**PETITION FOR CHANGE OF THE PROJECT DESCRIPTION IN THE FINAL
DECISION TO AUGMENT COOLING TOWER MAKEUP WATER WITH
WATER RECLAIMED ONSITE**

**PALOMAR ENERGY CENTER
(O1-AFC-24C)**

**SAN DIEGO GAS & ELECTRIC COMPANY
SAN DIEGO, CALIFORNIA**

June 22, 2017

PALOMAR ENERGY CENTER OVERFLOW POND EXTENDED TOPOGRAPHICAL SURVEY

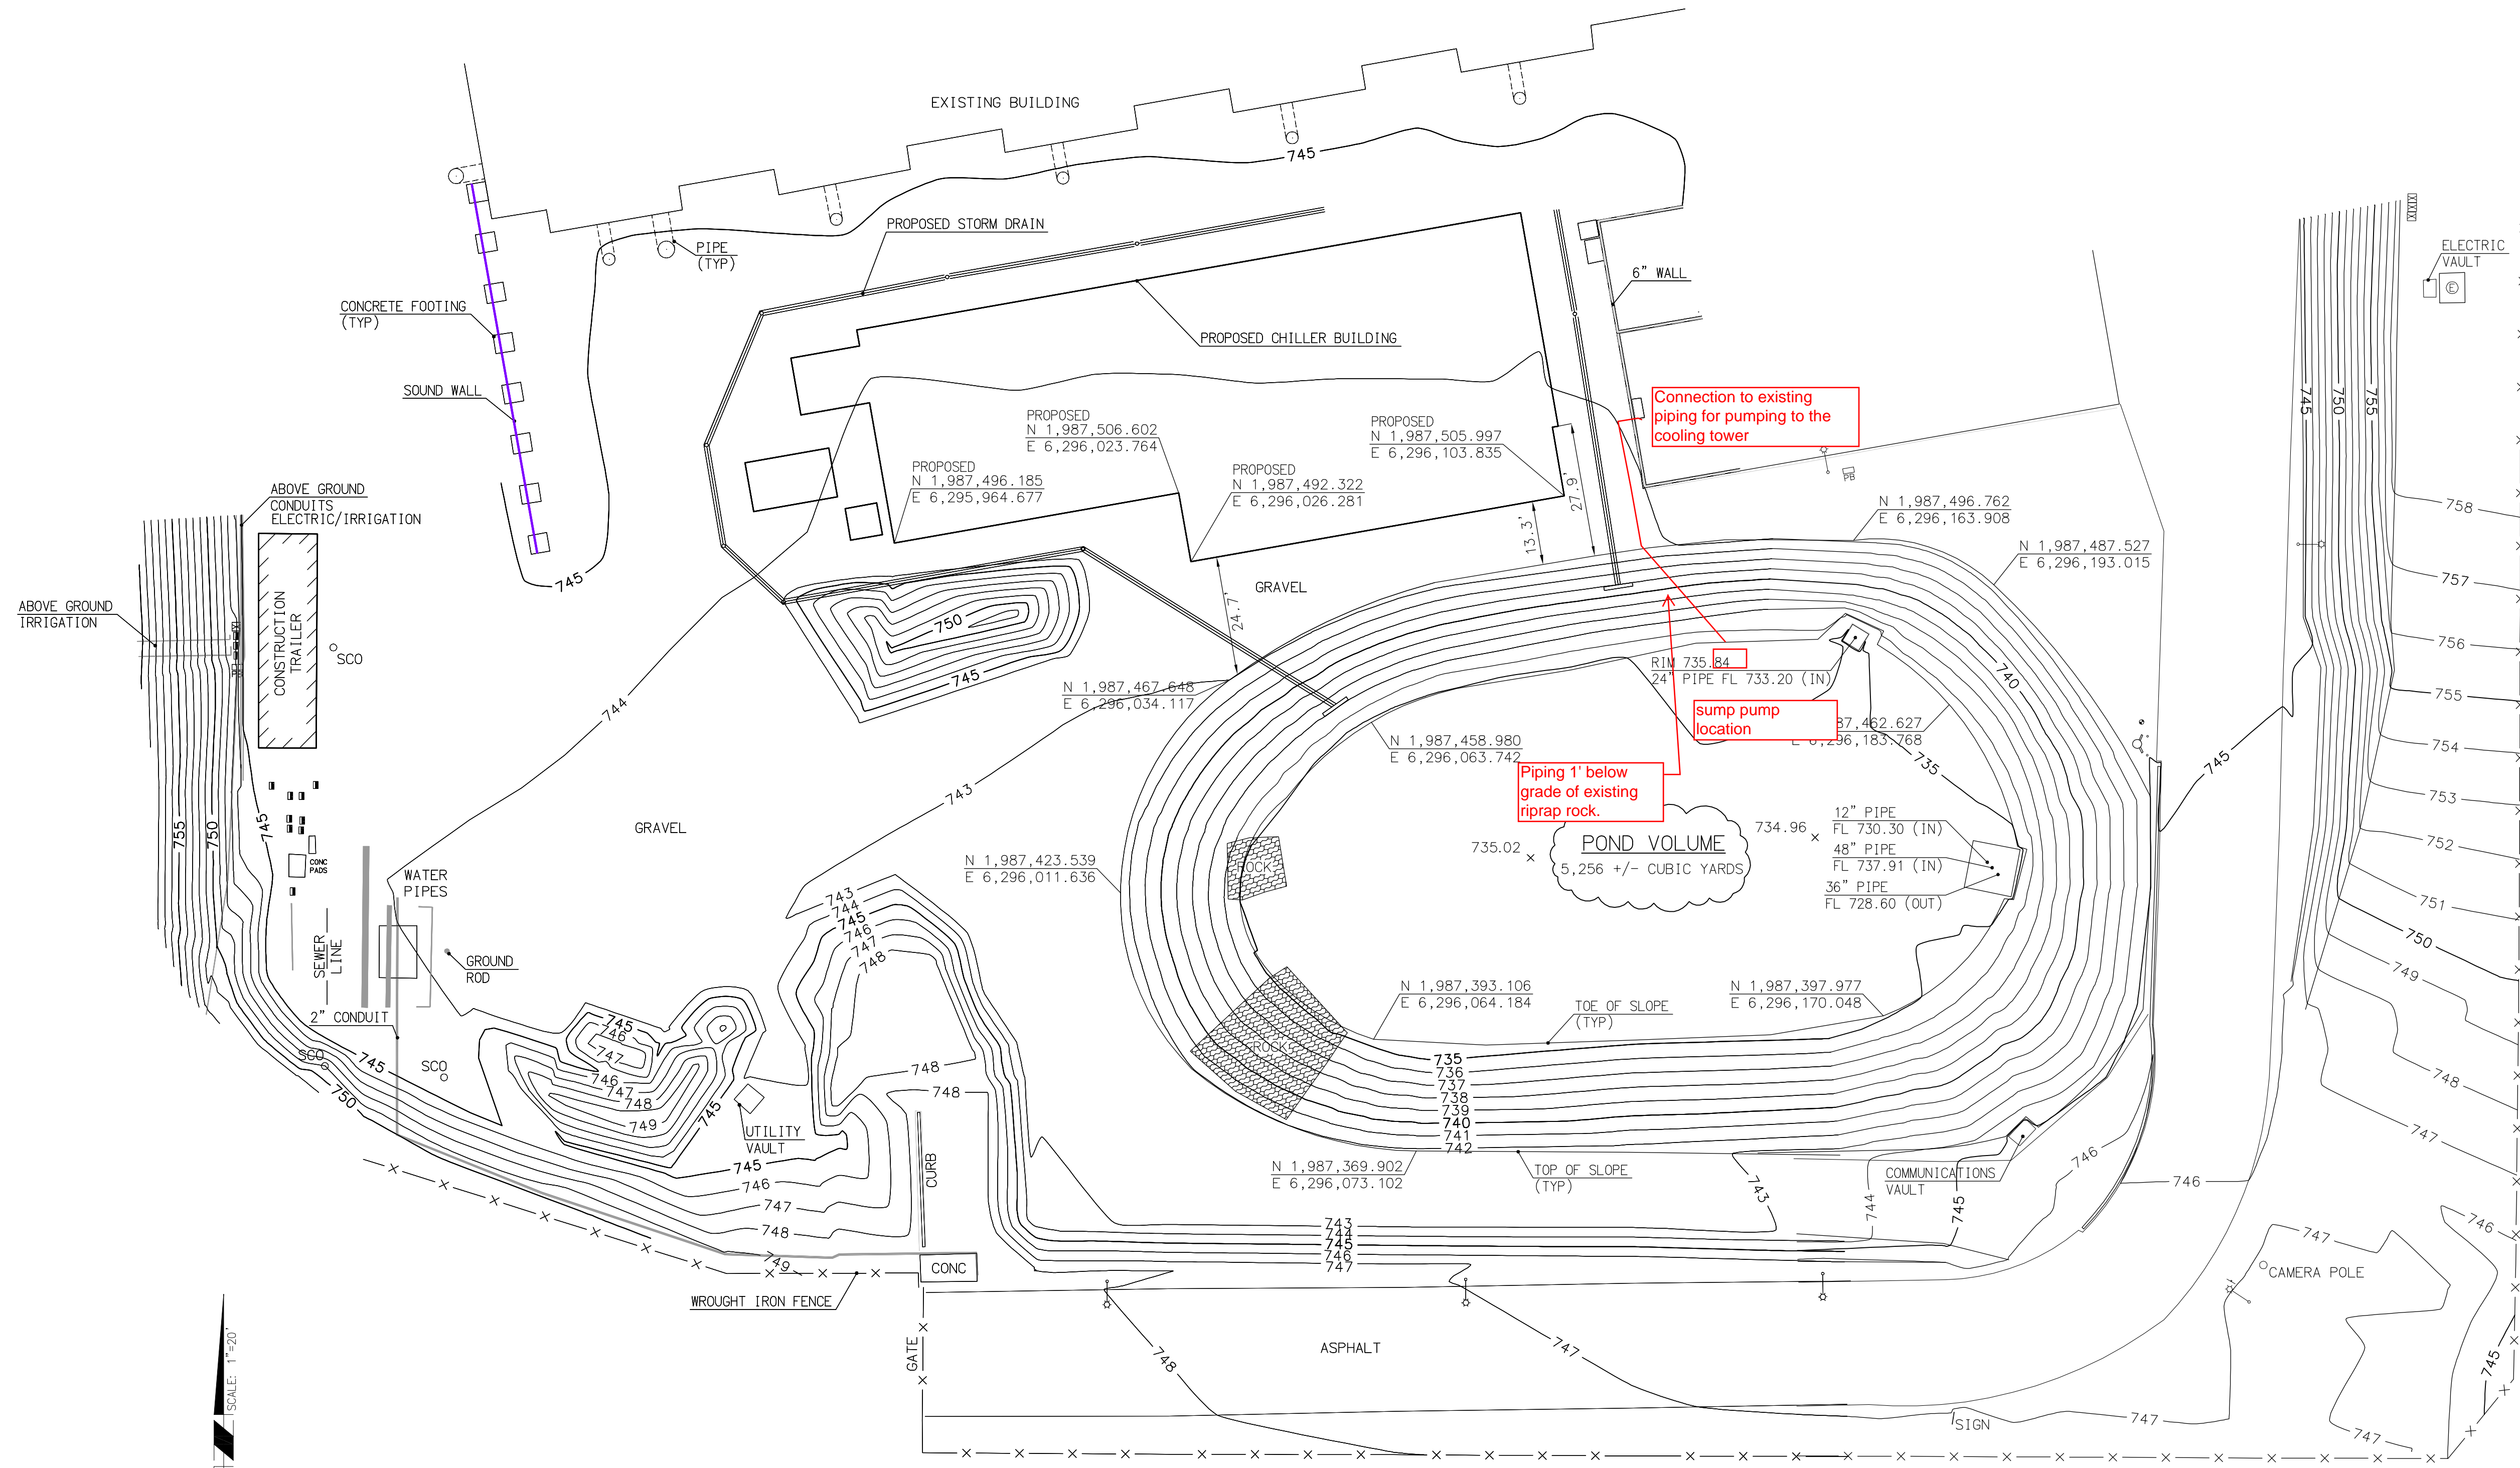
The storm water reclamation portion of the project will be achieved by installing a small sump pump to the existing storm water basin and routing the discharge piping less than 50 feet to an existing piping rack at the chemical storage area. Power is also available at the chemical storage area. Construction activity will consist of:

- Constructing a small concrete sump and the bottom of the storm water basin.
- Making an approximately 13 foot long, 1 foot wide, cut across an existing road.
- Making an approximately 17 foot long, 1 foot wide, excavation parallel to, and at the same or less depth as, an existing drain pipe between the chemical storage area containment and the chiller building.
- Utilizing an existing pipe rack at the chemical storage area to route the discharge piping to the cooling tower.

The entire PEC is substantially shielded from view on the north, east, and west by an earthen berm. In addition to this berm, the sump pump (approximately 2 feet tall) will be located in a small sump at the bottom of the approximately 7 feet deep storm water basin. The Sump pump is not expected to extend more than 1 foot above the current finish grade of the storm water basin floor. This area is further hidden by the chiller building and the Thermal Energy Storage Tank.

Please see Appendix III and Appendix IV for additional installation details.
